Application for Planning Approval

DA2026/180

JORDAN DOWNS RESIDENCE

Response to request for information

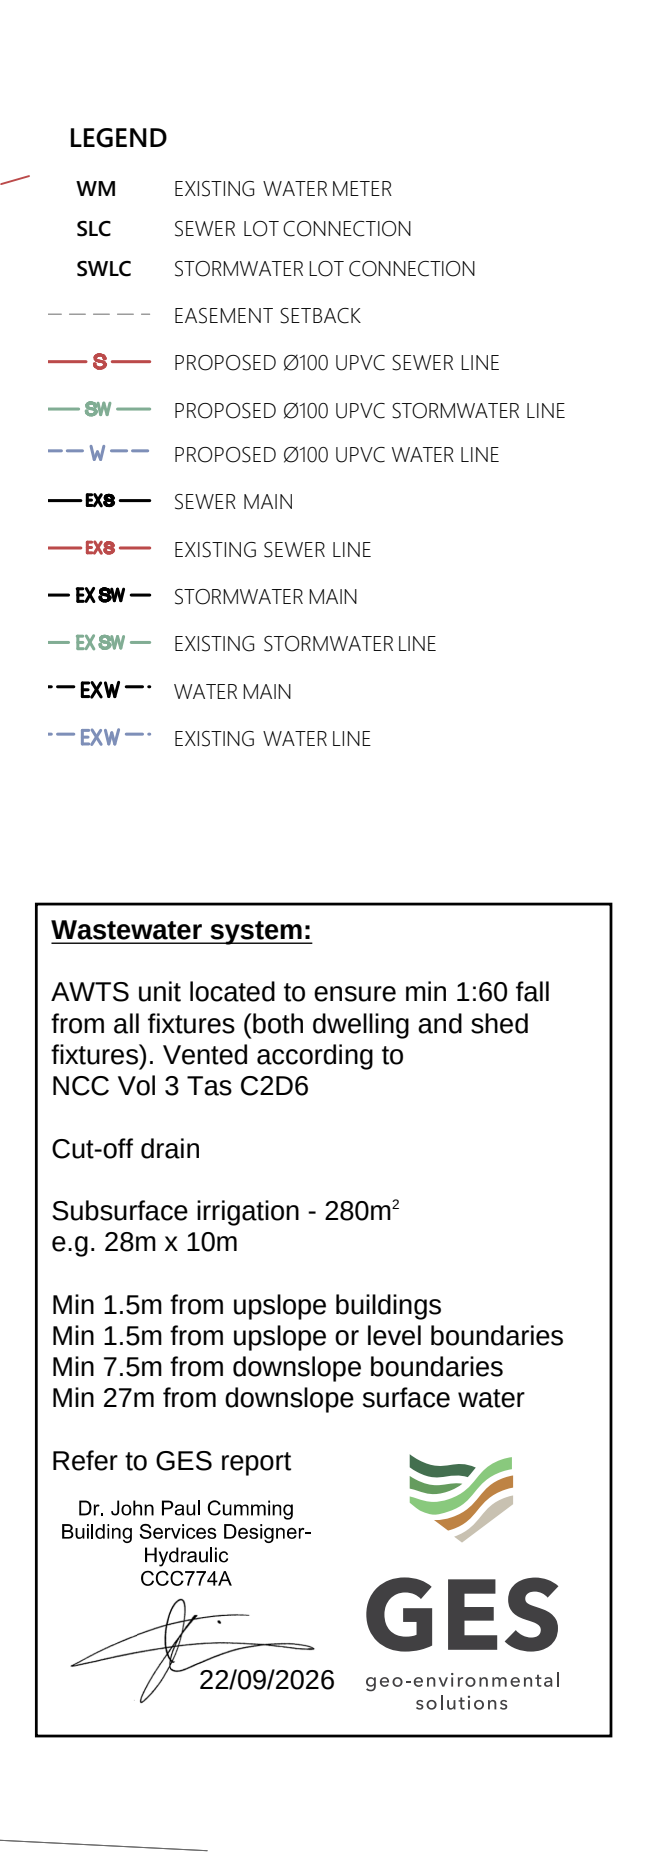
4. Provide a preliminary on-site wastewater management design, including the location and extent of all effluent disposal areas.

Wastewater management design has been undertaken by Geo-Environmental Solutions. The report provided details the location of the proposed AWTs system and subsurface irrigation area. This has also been representationally shown on the updated site plan, page DA03.

Cut-off drain detail - typical grassed swale drain

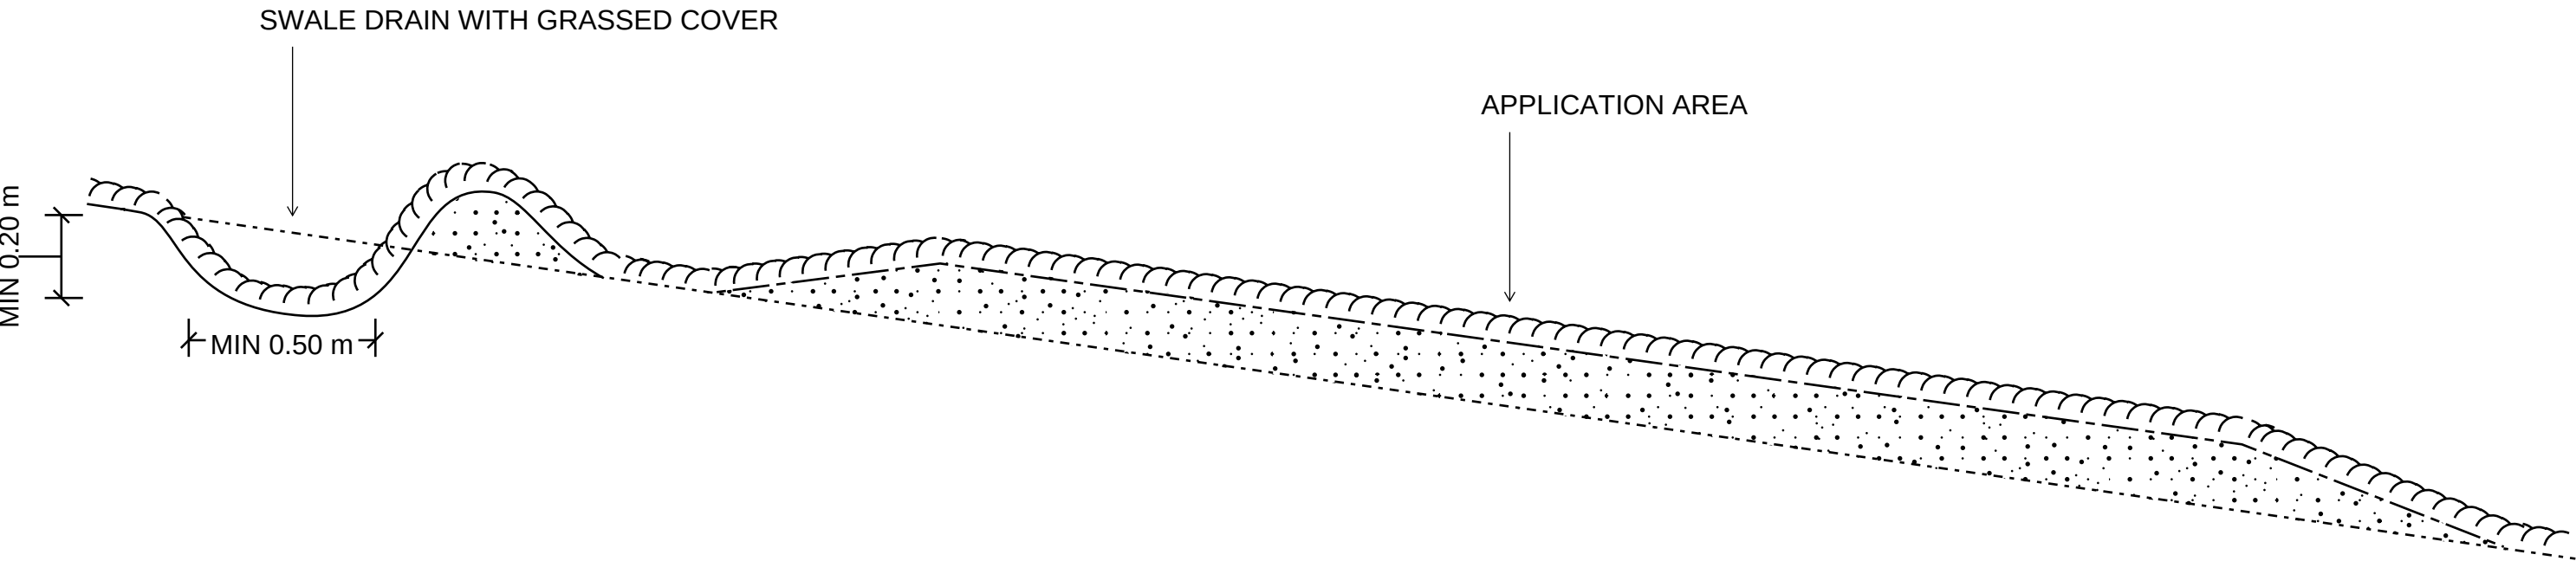
3. STORMWATER DISPOSAL

Stormwater overflow will be directed to a 20m-long arch absorption trench in the south-eastern portion of the property, downslope of the dwelling and shed, for on-site disposal.

The trench location is shown on the updated site plan. Refer to the accompanying detail for the absorption trench and arch configuration.
